Design Review Subcommittee (DRSC)

Meeting Date: February 12, 2020

SUBJECT: **Minor Cultural Heritage Permit (MCHP) 19-035 and Discretionary Sign Permit (DSP) 20-044, Beach Hut Deli Façade and Signage,** a request to remodel the façade of an existing commercial building and install more than 25 square feet of signage for a business at 1844 N. El Camino Real within the MU1-A-CB-CZ zone.

Project: MCHP 19-035

Figure 3 –Northwest Elevation from 1st Review

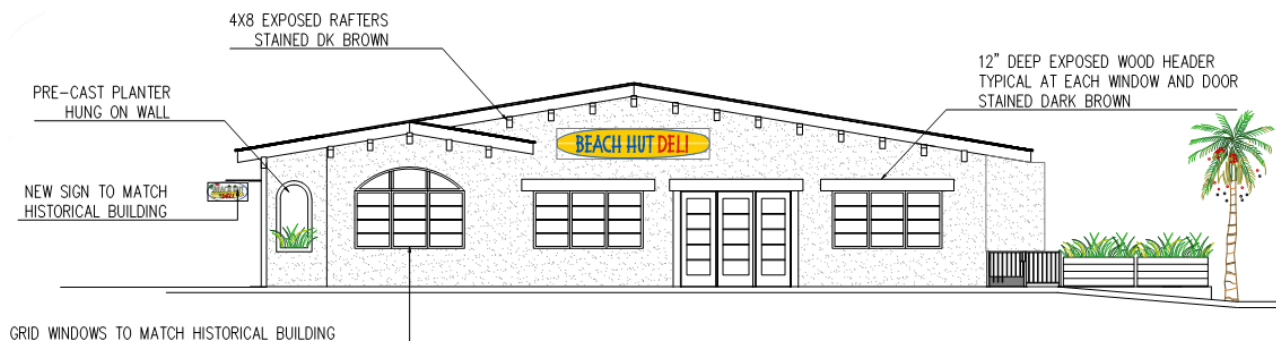
Figures 3 and 4 provide a comparison of the front elevations from the two versions of the proposal. There are a few notable improvements from the prior proposal. First, the primary entry is accentuated with a pop out covered entry which adds noticeable relief and shadowing to the primary elevation. The parking stalls at the front entry have been resized to meet current standards and shifted appropriately to provide a paver lined walkway leading into this front entry. Pockets for climbing vines are proposed on both sides of the covered entry posts to incorporate greenery into the aesthetic. Second, the wing walls are balanced with segmented arch openings to provide relief on the primary elevation. Third, a faux chimney is proposed to be attached to the rear elevation to help conceal standing pipes. This would reduce clutter, provide an SCR accent element, and provide some variation to the roofline. Fourth, a simplified oculus vent feature on the rear elevation replaces the pop-out “SCR element” from the previous iteration that was recommended to be removed by staff and DRSC. Finally, the El Camino Real Elevation has been improved to expand the posts into stucco clad columns supporting segmented arches that frame the windows behind.

Figure 3 – Proposed Rear Elevation – Southeast

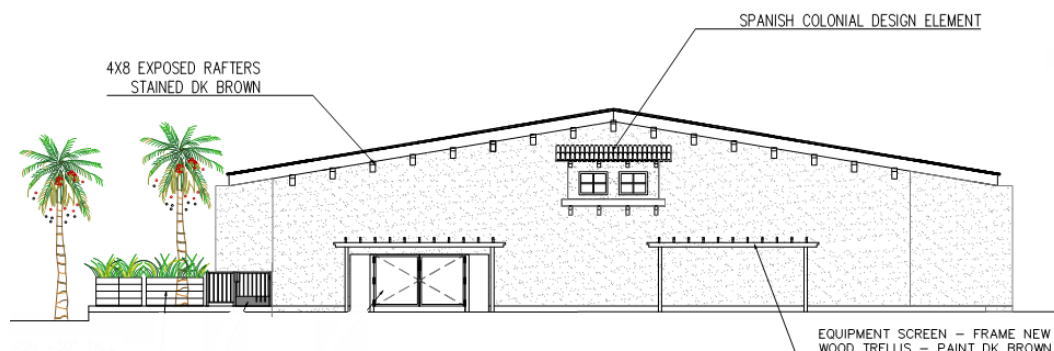
- Stated the proposed "SCR design element" on the southeast (rear) elevation appears tacked on and should be replaced with a simpler design element (i.e., oculus with iron grill).

- Stated the proposed pergola over the propane tank provides insufficient screening. Recommended exploring alternatives, such as two smaller indoor tanks. If an underground gas line is not feasible and propane cannot be moved indoors, then full screening at rear is necessary. Requested that OCFA comment on the location of the propane tank.
